Bulletin No. 2003-15

FourStroke 9.9/15HP Camshaft Washer Failure

Model	Serial Number or Year
Mercury/Mariner 9.9/15 HP FourStroke Outboards	2004 Model Year 0T849201 through 0T908966

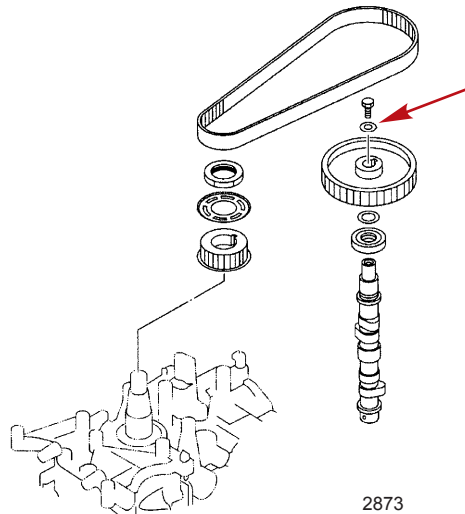
The camshaft pulley washer on the affected outboards has the possibility of developing a crack. The failure of this washer could cause the camshaft pulley to become loose and allow the valves to contact the piston.

Installation of a replacement washer (part number 12-825498) is required.

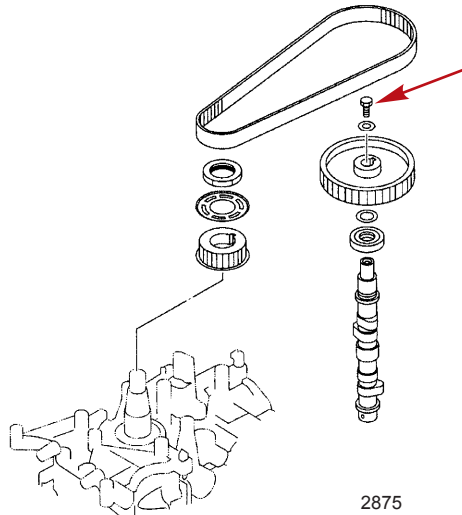
1. Remove driven gear cover.

2. Remove camshaft driven gear bolt and washer.

3. Install new washer and torque the driven gear bolt to specification.

Description	Nm	lb. in.	lb. ft.
Driven gear bolt	13	115
